GOVERNMENT OF THE DISTRICT OF COLUMBIA
DEPARTMENT OF TRANSPORTATION

MEMORANDUM

SUBJECT: BZA Case No. 19175 – 2 I Street SE

Figure 1 Site Plan (Source: Gorove/Slade)

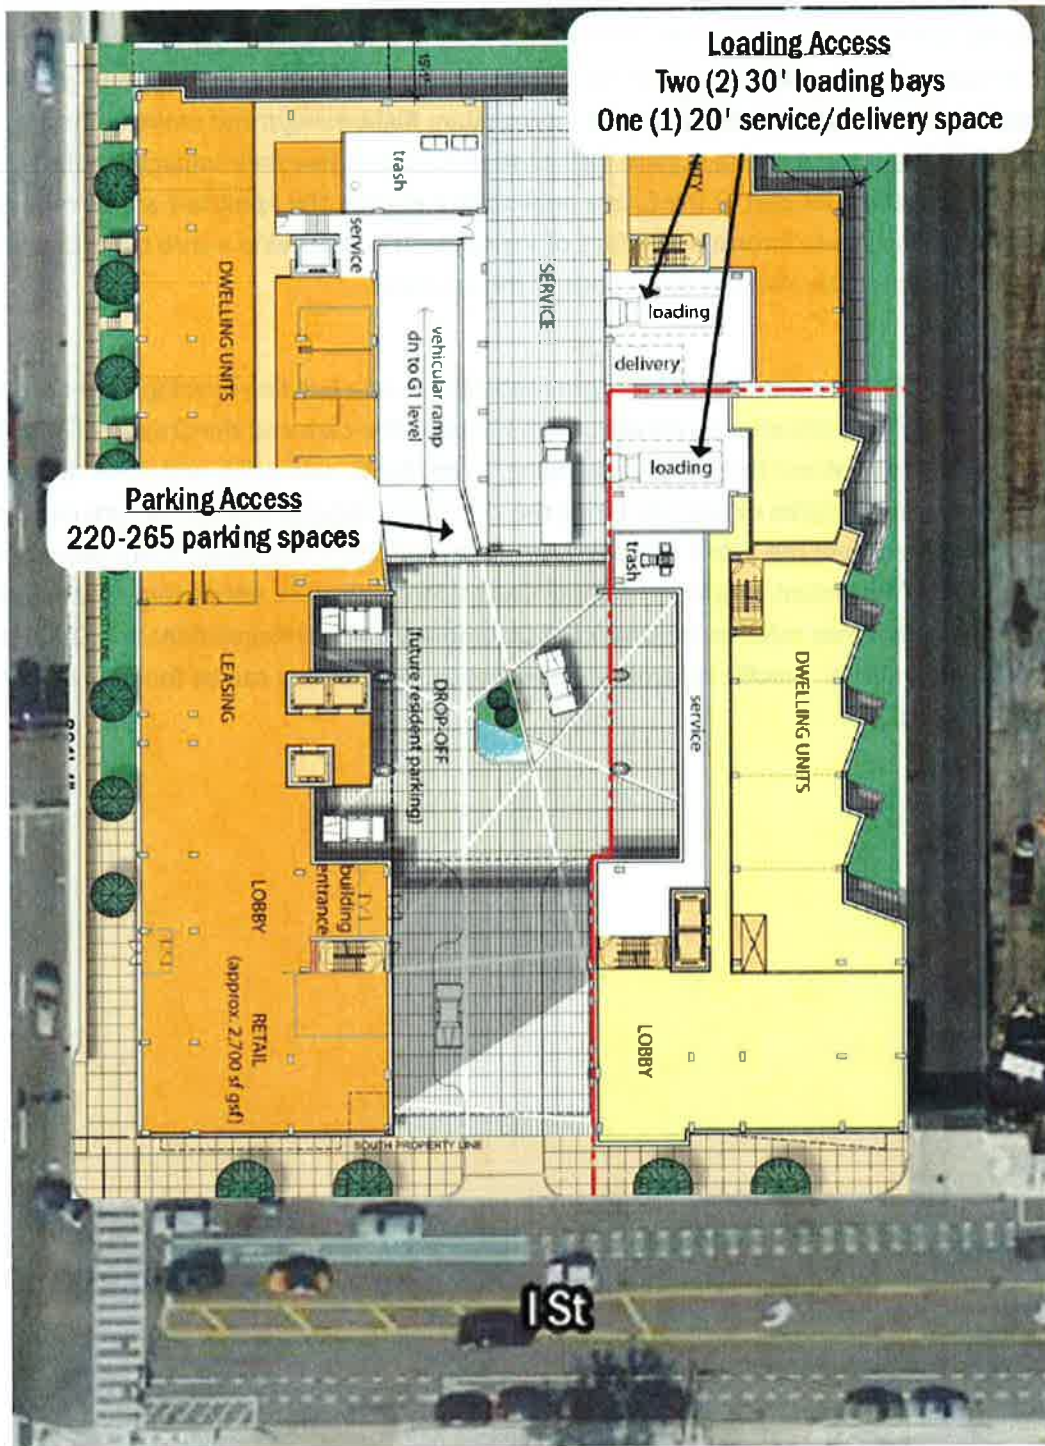
Based on the information provided the requested variance from loading requirements to provide two 30-foot loading dock in lieu of the required one 55-foot loading dock will have no adverse impacts on the travel conditions of the District's transportation network. The 30-foot loading berths are likely sufficient to accommodate move-in/move-out truck activities associated with the proposed residential unit size mix. The requested loading relief is consistent with other loading-related relief requests throughout the District. In the rare event that larger trucks must service the site, Emergency No Parking signs are available from DDOT to reserve a loading area along the curbside on I Street. Of note, the temporary loading area would need to occupy legal parking spaces, and therefore cannot be located directly adjacent to the site on I Street or South Capitol Street because parking is not allowed. The closest eligible temporary loading area is the approximately 80-foot long curbside parking area located on the north side of I Street about 30 feet east of the site.

Loading for the retail space, which is not directly connected to the on-site loading facilities, would need to occur from the driveway on private space and will not be allowed from either I Street or South Capitol Street adjacent to the site.

Site access for vehicle parking and loading is proposed to be from a single curb cut on I Street. The Applicant received concept approval for the curb cut at the Public Space Committee's January 28, 2016 hearing. Although concept approval was granted, final design will be determined in the future through a separate public space permit. DDOT notes that full-movement operations of the curb cut are highly unlikely to be permitted. Specifically, left-in movements are the most problematic due to potential queuing into the South Capitol Street & I Street intersection. Right-in/right-out movements are acceptable, and left-out movements require further study to determine their impacts on the surrounding intersections. As part of the future public space permit, the Applicant will be required to provide additional analysis to inform operations of the curb cut and develop a curb cut design and signage plan to reinforce the ultimate operations of the driveway.
